Titanium Dioxide Pigment Plant Kwinana
Cooljarloo Joint Venture

Report and Recommendations
of the
Environmental Protection Authority

Environmental Protection Authority
Perth, Western Australia
Bulletin 373 February 1989

Figure 5. Revised Wastewater Scheme for the Pigment Plant. (Source Proponent's Responses to Submissions).

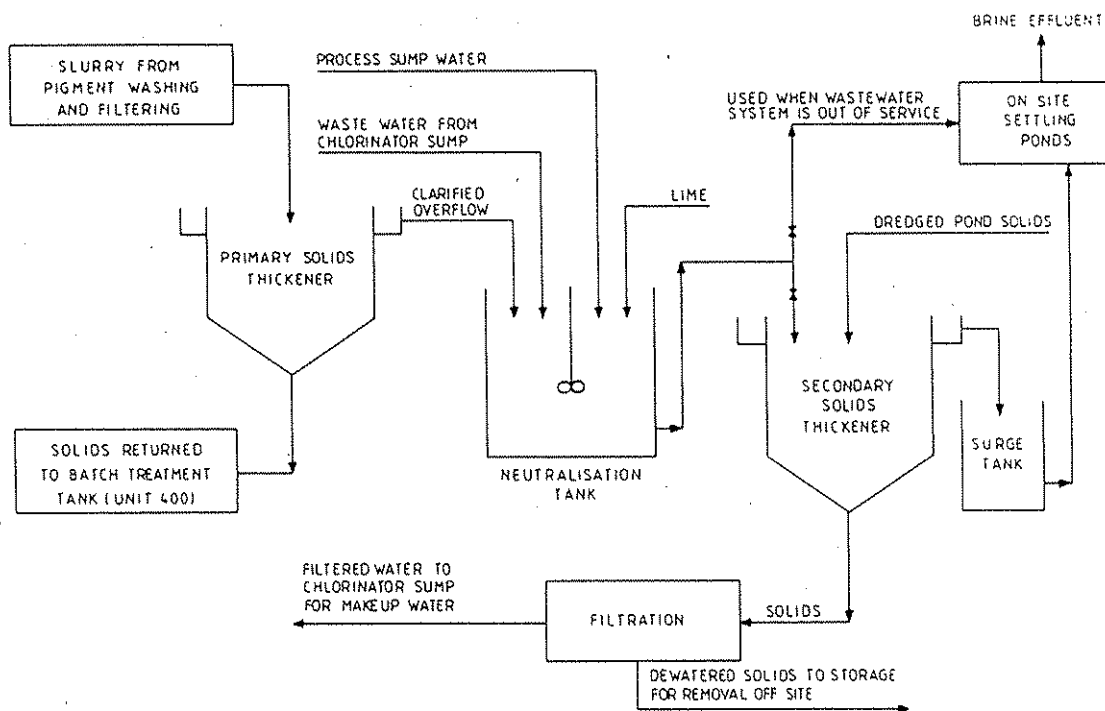
Since the ERMP was released the proponent has revised the wastewater scheme for the pigment plant. The revised scheme is shown in Figure 5. The modification is designed to enhance the recovery of solids from the process.

The treatment system receives slurry from the pigment washing and filtering area. The slurry initially passes to a solids thickener where solids are settled out of solution. Solids from this area are returned to the process whilst the liquid fraction is directed to a neutralisation tank where lime is added to precipitate heavy metals. The resulting solids are then removed prior to disposal by landfill. The clarified effluent is directed to a surge tank which directs the treated effluent to one of two lagoons. These lagoons will be lined with impervious membranes and occupy an overall area of 30 000 m².

Figure 6. Incinerator system for the Pigment Plant (Source Proponent's responses to Public Submissions).

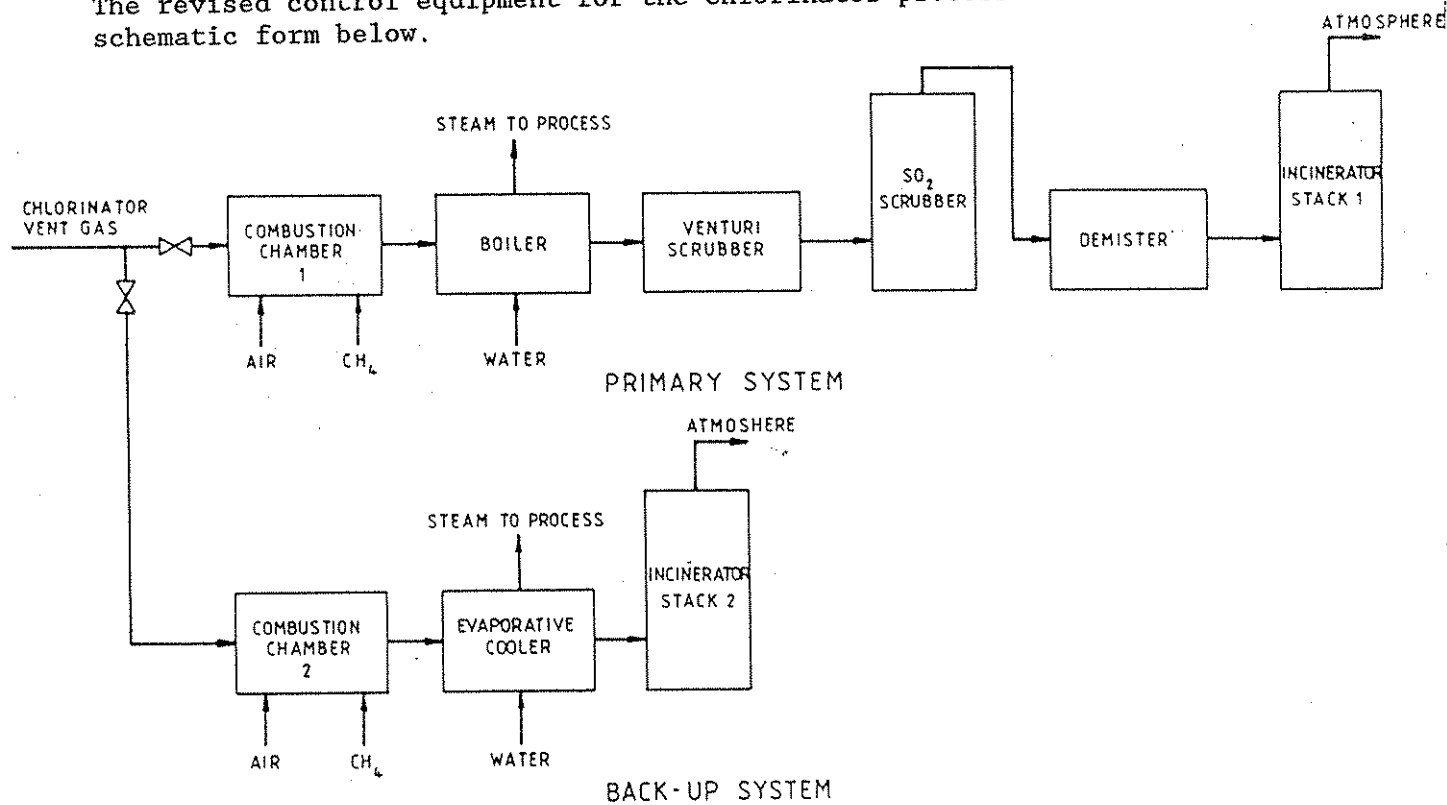
The ERMP does not address the subject of emissions control systems in any great detail. However, as a result of questions raised by the EPA a revised emissions control system has been developed to greatly reduce the emission of reduced sulphur compounds and carbon monoxide.

The revised control equipment for the chlorinator process vent is set out in schematic form below.

FIGURE 2

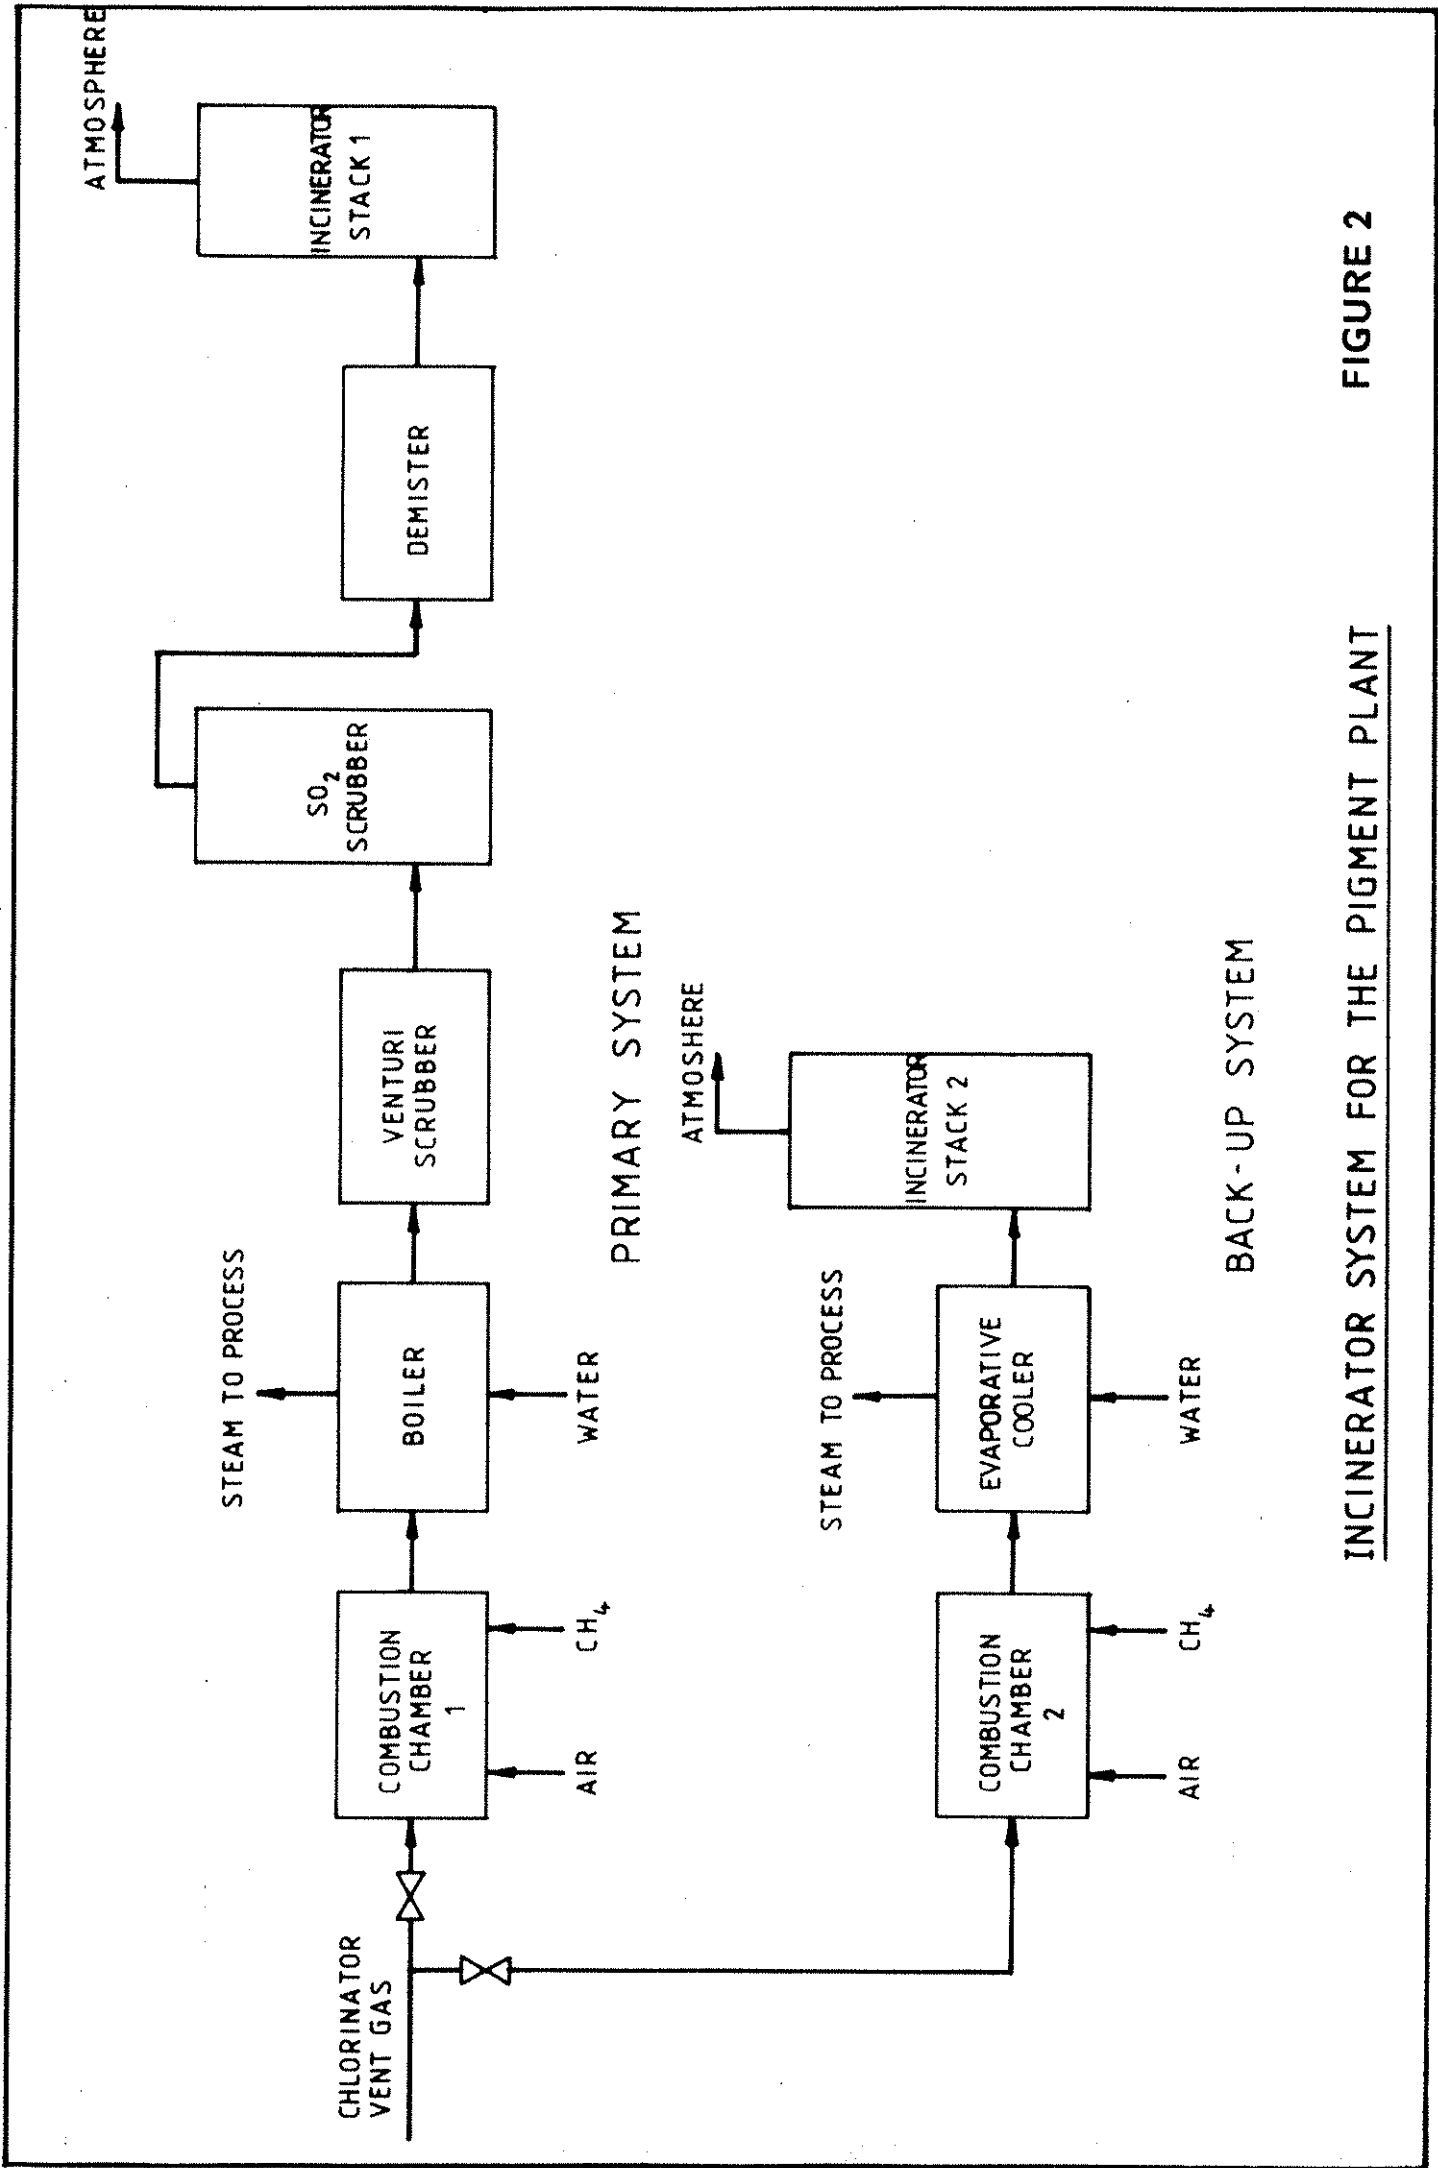
Further refinements have been made to the atmospheric emission control equipment since the ERMP. The chlorinator vent gas, vented through Stack 202, will be cleaned by an incinerator system similar to that used at the Hamilton plant (see Figure 2).

The combustion chamber will convert the sulphurous compounds to sulphur dioxide (SO_2) and the carbon monoxide (CO) to carbon dioxide (CO_2) with an efficiency of 99.95%. The gas will then be cooled in a boiler before being scrubbed of SO_2 and vented to the atmosphere.

The incinerator on-line efficiency is 85% and the overall plant efficiency is 95%. The 10% of the time that the incinerator will be down while the plant is still operational the chlorinator vent gas will be directed to the back-up incinerator system (see Figure 2). This system will convert the sulphurous compounds to SO_2 and the CO to CO_2 as in the primary system. The gas will then be cooled in an evaporative cooler before being vented to atmosphere.

FIGURE 5

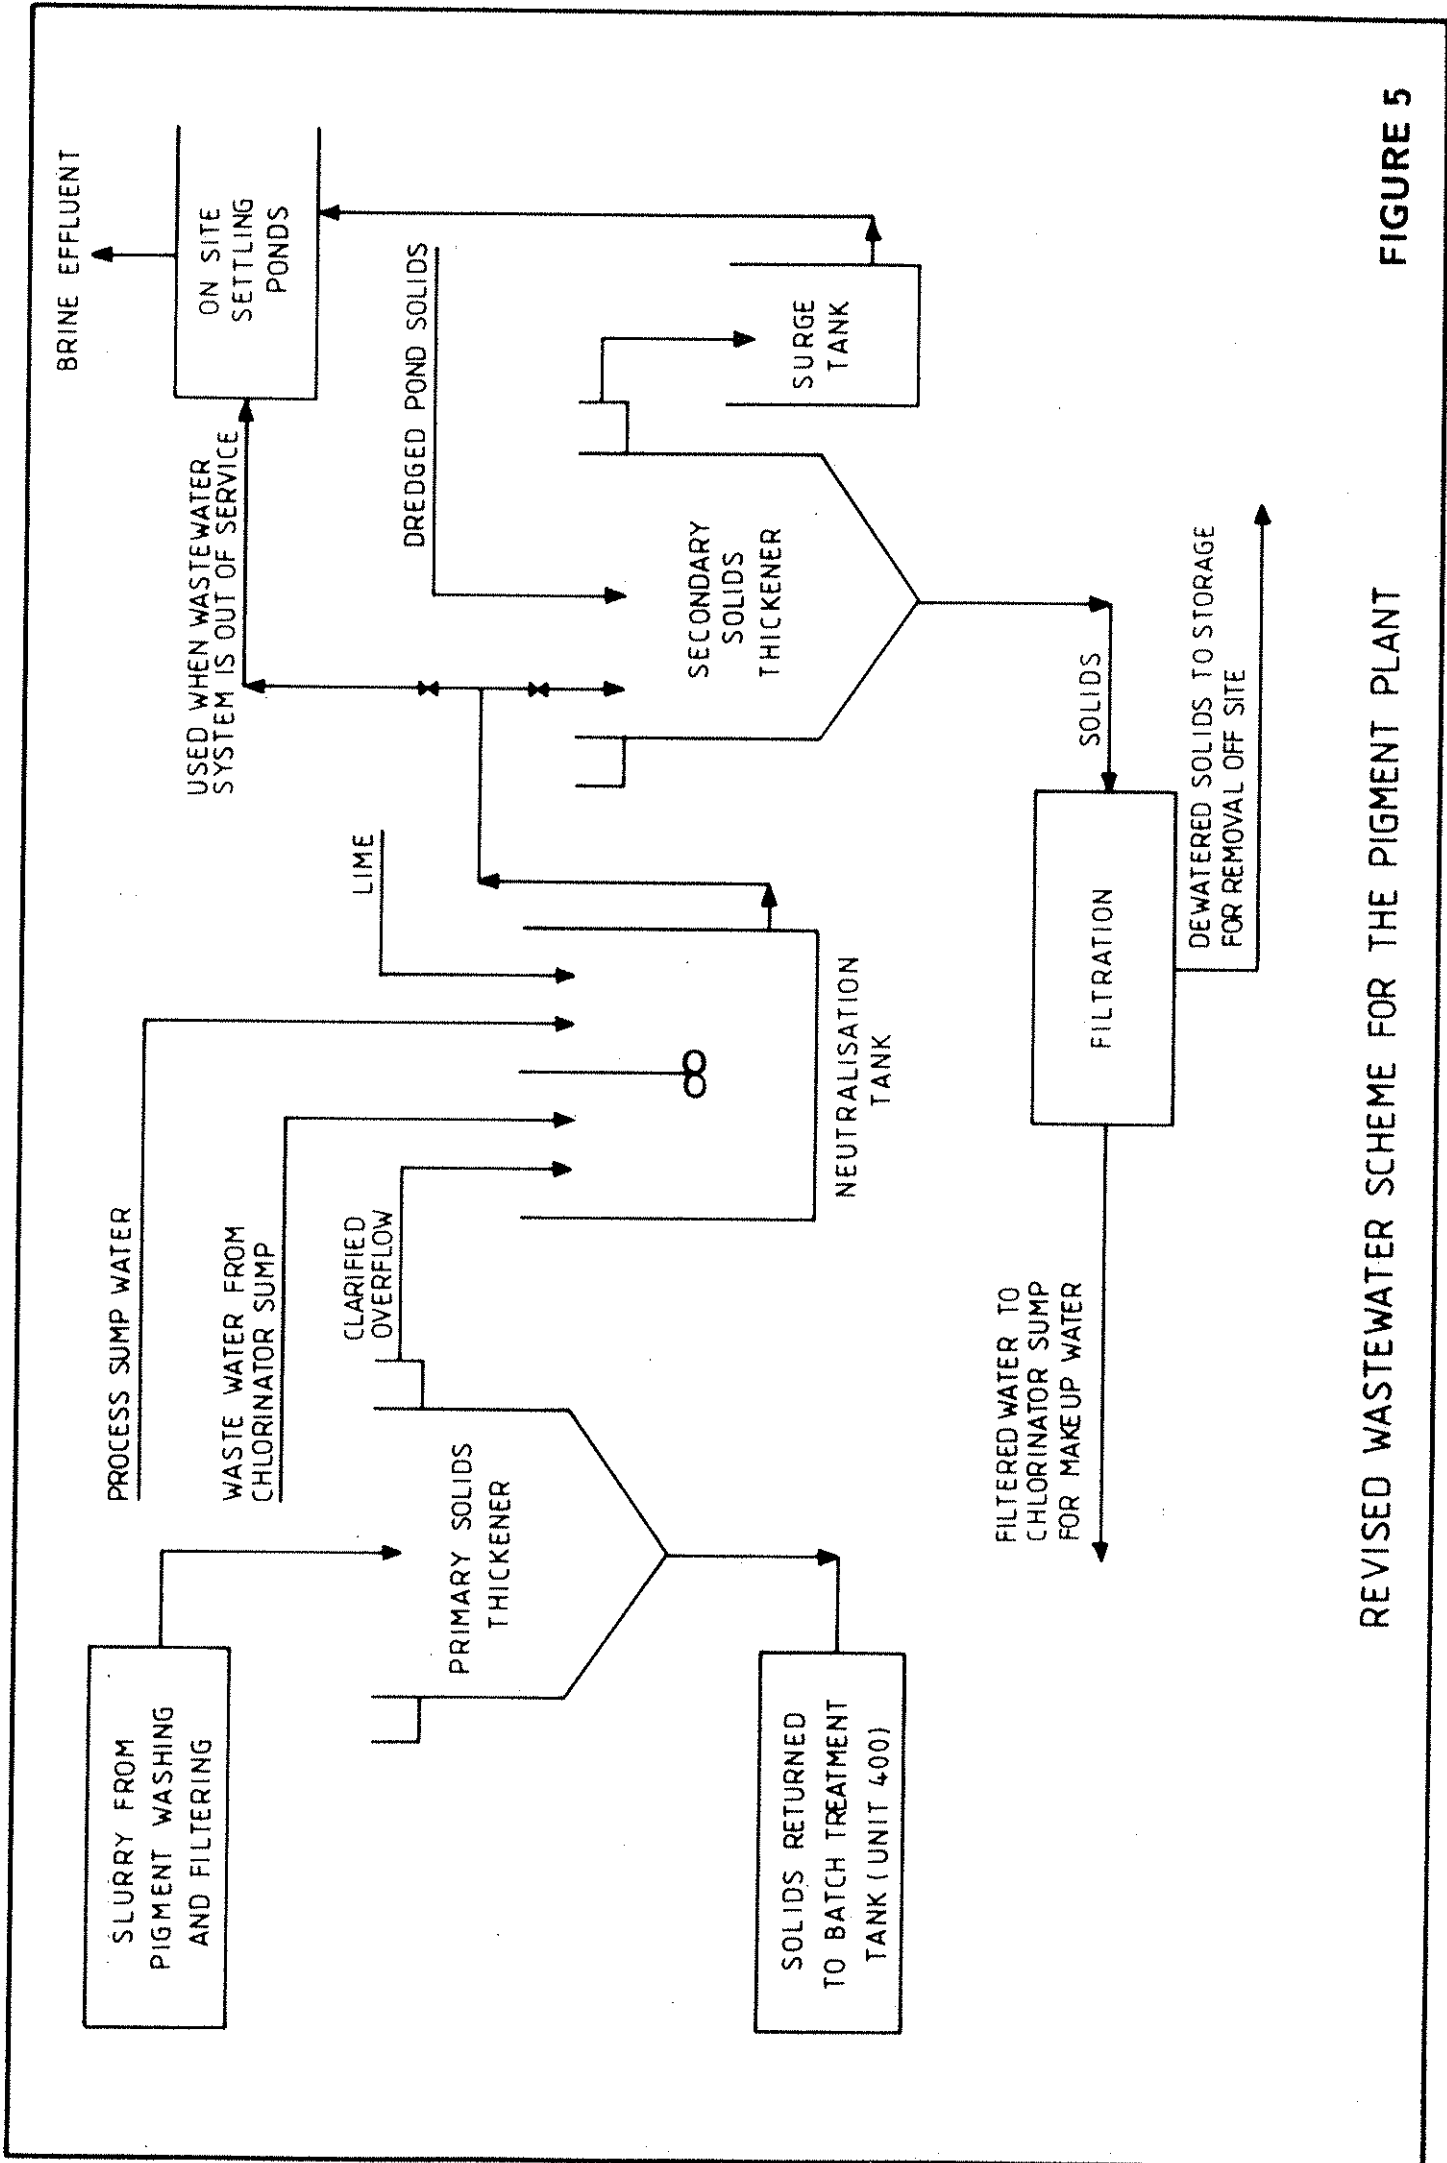
The wastewater treatment system for the pigment plant has been revised as follows. Figure 5, the revised ERMP Figure 4.10, is a flowsheet detailing the updated wastewater treatment system.

Process wastewater will be pumped to a neutralisation tank for pH adjustment and then to a solids thickener. It may be necessary to add flocculant to aid in settling in the solids thickener. A research project is currently being conducted to study settling rates. The results of this study will be used in the final design of the wastewater treatment system.

The overflow from the solids thickener will be pumped to one of two on-site settling ponds. The settling ponds will be used to settle out any solids that are not removed in the solids thickener. The discharge from the operating pond will overflow to either Cockburn Sound or Cape Peron Outfall. The second pond will be kept as a spare pond or backup pond.
